CANCELLED
AIRWORTHINESS DIRECTIVE GLIDERS

REF. NO. GFA/AD/178 GENERAL 4.

GLIDER TYPES AFFECTED.

SKETCH 1

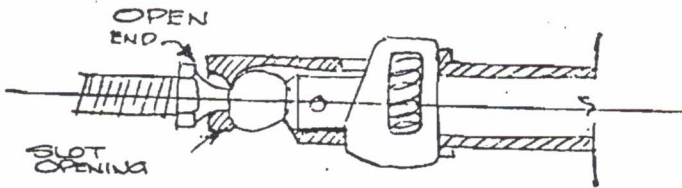
There are two basic forms of ball joint coupling in use. One type is designed for a side connection where a push rod connects to a lever. The other type of coupling is designed for an in line connection such as where one push rod connects with another push rod and the push rod operating forces are more or less in line.

The female part of the coupling of the first mentioned type has a closed end and it cannot be used as an in line coupling.

All gliders fitted with ball joint couplings with side connections are to be inspected before further flight, to ensure the correct type of female connection is fitted. If an open ended type female coupling is fitted it is to be replaced with a closed end type. If any discernable wear marking is evident on the mating ball component, the ball and female part of the coupling are both to be replaced before further flight.

Alternatively the ball part only may be replaced but the female part of the coupling must be replaced within twenty five further hours in service.

SKETCH 2.

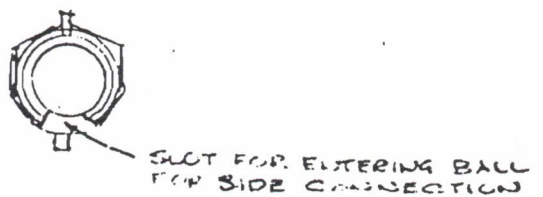
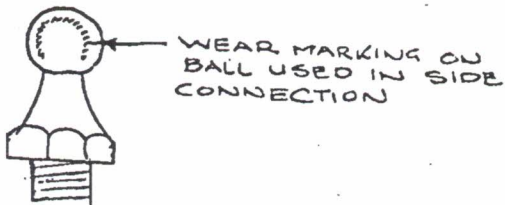
The female part of the coupling of the second mentioned type has an open end and it is possible to use this type of coupling as an in line or as a side connection type, however when used as a side connection coupling the ball part of the coupling is subjected to more rapid wear due to the reduced bearing surface at the open end of the female part of the coupling. The resulting wear pattern can lead to the female part of the coupling obtaining a clamping grip on the ball part of the coupling and any rotary movement can lead to failure of the ball shank.

Tests have shown that approximately two degrees of twist between the ball and its shank can cause failure.
